LAKE PONTCHARTRAIN, LA. and VICINITY LAKE PONTCHARTRAIN BARRIER PLAN

DETAILED DESIGN MEMORANDUM NO. 8 RIGOLETS LOCK VOLUME 1

SUBJECT: Lake Pontchartrain, Louisiana and Vicinity, Lake Pontchartrain, Barrier Plan, Detail Design Memorandum No. 8, Rigolets Lock

- 1. The subject feature design memorandum is forwarded for review pursuant to para 21a(7), ER 1110-2-1150. Approval is recommended subject to final resolution of the lock size and the comments in the following paragraphs.

FILE NO H-2-24419 PLATE V4

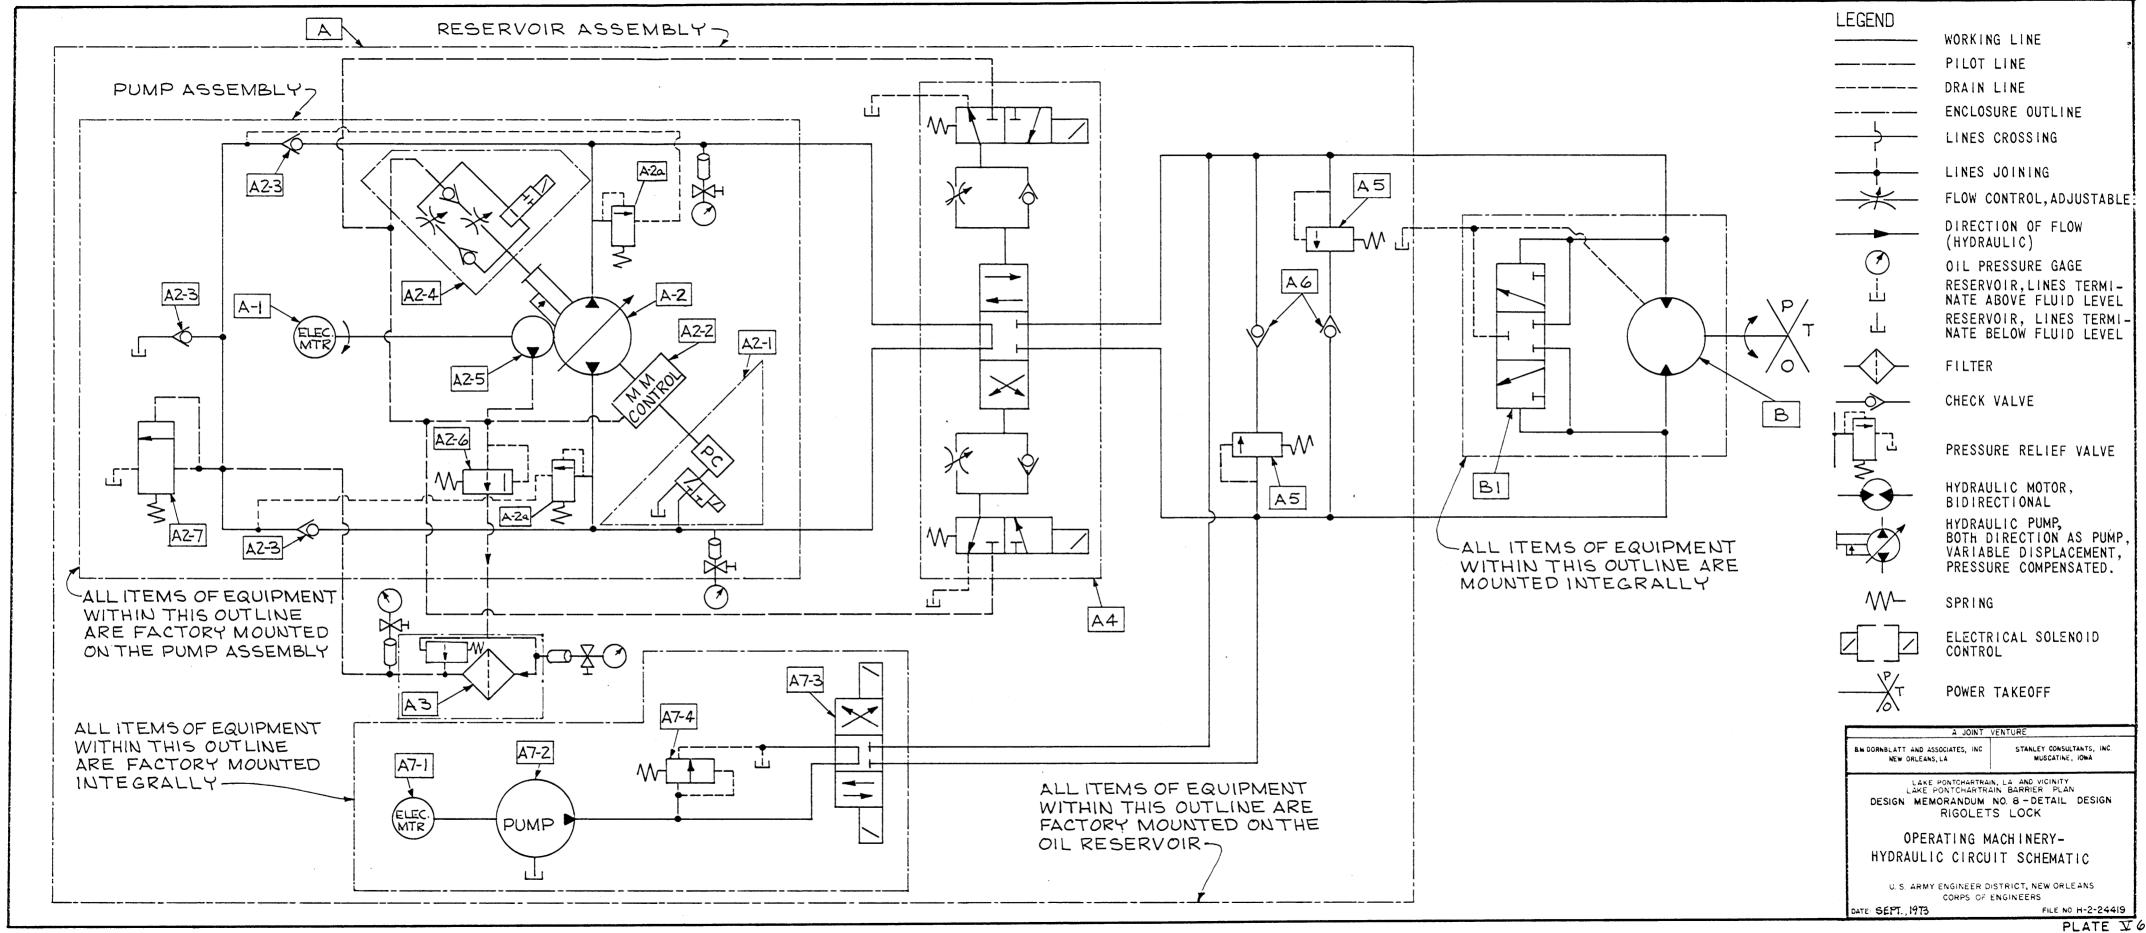
- e. Plate V4. Consider raising the control house floor at el 19.5 approximately 2 ft to provide adequate headroom in the machinery space.
- f. Plate V4. Consider locating the horn compressor on the operating floor instead of in the machinery space.

- 31. Para 5e. Do not concur. Freshwater Bayou Lock has the same headroom, and it has proved to be satisfactory.
- 32. Para 5f. This comment is superseded by para 2 in the 2d Ind.
